Docket Item # 3
BAR CASE #2012-0205

BAR Meeting
July 25, 2012

ISSUE: Re-approval of previously approved plans for Alterations (storefront window)

LOCATION: 119 North Washington Street

Figure 2. Current proposal and 2008 design approved by BAR (BAR Case #2008-0006, 2/6/2008).

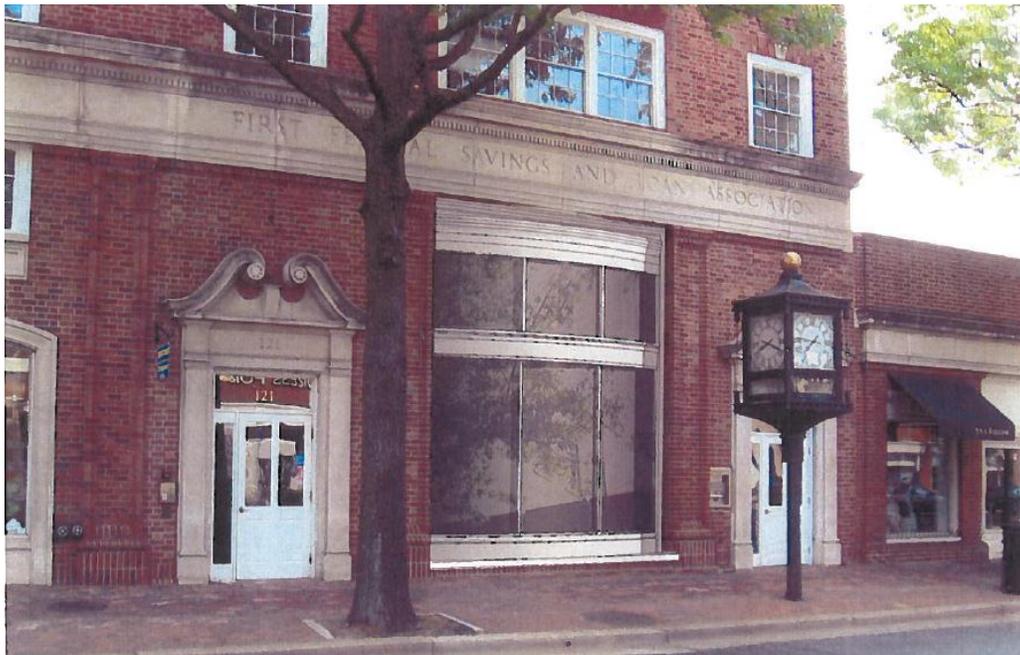
As with the previous, identical proposal of 2008, Staff finds the current proposal to be appropriate and compatible with the Colonial Revival style of the building and a significant improvement over a scheme that the Board also approved in 2007.

In 2008, after the applicant determined that the previously approved design (above) was not feasible, the applicant returned to the Board with a revised scheme. The Board approved the revised scheme (below), which also included a sign band and pronounced cornice.

However, Staff does not believe that this building is so unique or distinguished that it must be preserved as-is and believes that alterations to accommodate modern uses can be appropriate, so long as they are compatible. Staff finds the current proposal to be appropriate and compatible, as

it utilizes a Colonial Revival vocabulary and does not detract from the overall integrity of the building. The proportions of the storefront window glass recall the proportions of the adjacent entrance doors and their transoms. In particular, the storefront window now directly reflects the mullions of the tripartite windows on the second and third floors above which the present multi-pane window does not.

2 PROPOSED STOREFRONT WINDOW
SCALE: NTS

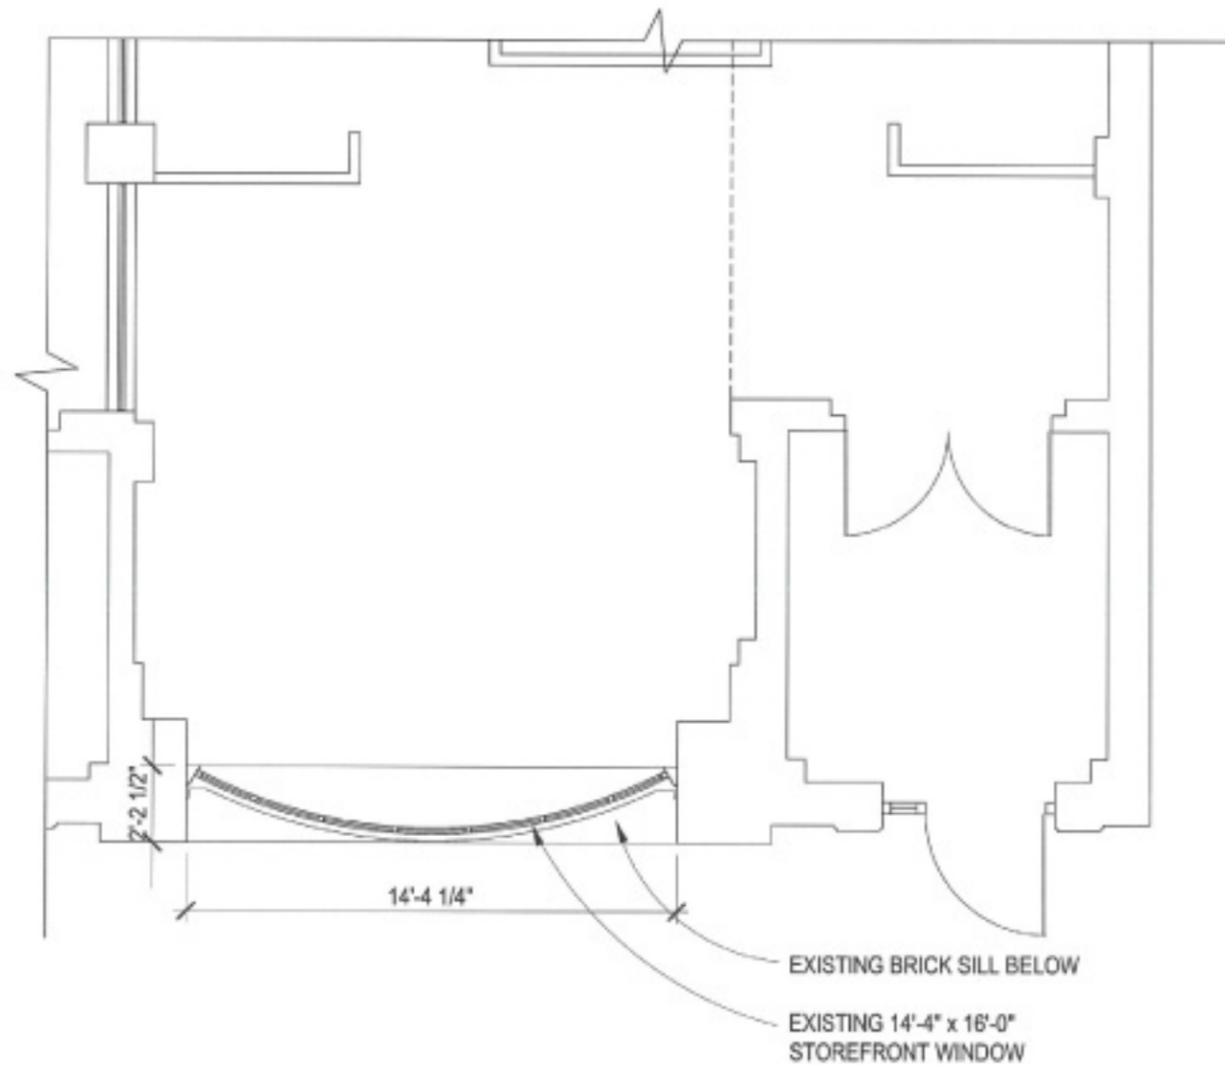
The applicant is requesting approval of a Certificate of Appropriateness at 119 South Washington Street to reconfigure the existing curved, multi-light, two-story window. The existing 56-light storefront window features true divided light glass panes with rectangular aluminum muntins. The proposed storefront window will continue to have curved glass but the light pattern will be reconfigured into a tripartite window configuration with a pronounced transom band and cornice above. The proposal is the same design that the Board approved in 2008 but which expired when it was not installed within one year of BAR approval.

While Staff's preference would be to retain the existing curved, multi-light window, Staff fully understands the marketing difficulty of using this multi-pane window from a former bank for retail storefront display, even for pedestrians.
